### REMARKS

Claims 25-41 are pending the application.

Fig.2

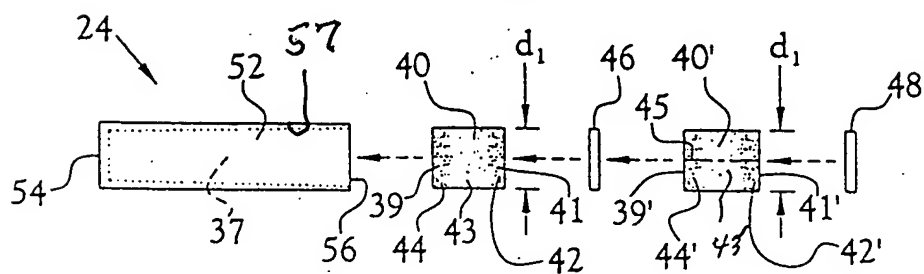
The drawings are objected to due to the absence of numerals 57, 59 and 49 from Figure 2. At page 11, the numerals "59" and "49" have been changed to "37" and "43," respectively. A Replacement Sheet which includes the missing numeral 57 from Figure 2 is submitted herewith. Also, a "proof" sheet of drawings, containing Figure 2 is included and on which the added numeral 57 is indicated in red for the Examiner's approval. Upon such approval, entry of the Replacement Sheet into the present application is requested.
